*Nomad***SERVICE BULLETIN**

SUBJECT: REINFORCING CHANNEL FITTED BETWEEN
STUB FIN FORWARD STRINGERS (MOD N477)

Installation of Reinforcing Channel
Figure 2

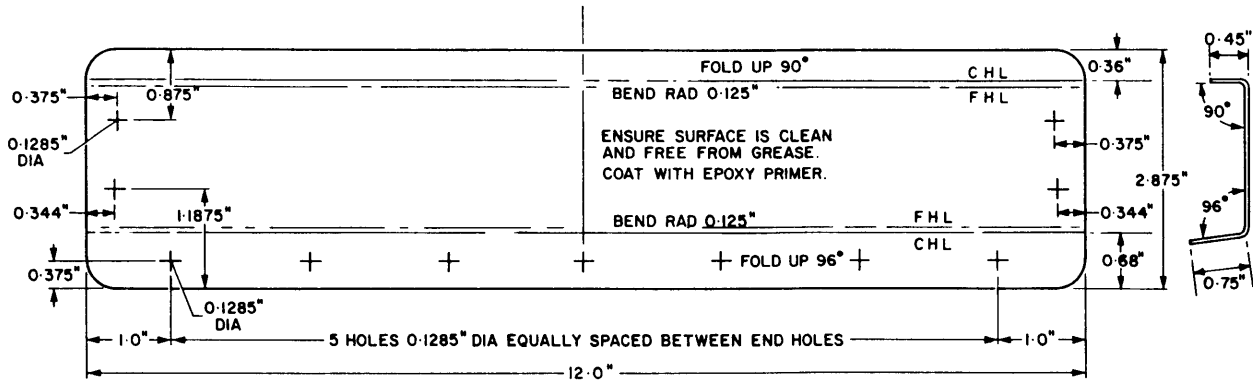
- E. Manufacture the reinforcing channel illustrated in Figure 1.
- F. Install the reinforcing channel.
 - (1) Hold the reinforcing channel in position (Ref Figure 2) and check that the bottom and vertical sections of the channel sit flush against the stub fin bottom rib and forward stringers, respectively. Fashion the channel, as necessary, to achieve correct fit.

- (2) Clamp the reinforcing channel in position.
 - (3) Using the holes in the reinforcing channel as a drill guide, drill seven 0.1285 inch dia. holes in the stub fin bottom rib and two 0.1285 inch dia. holes in each of the LH and RH front stringers.

- (4) Rivet the reinforcing channel to the stub fin structure using eleven 0.125 inch dia blind rivets (Ref Para 3.A.).
- G. Replace the inspection cover on the LH side of the stub fin and secure with the original screws.
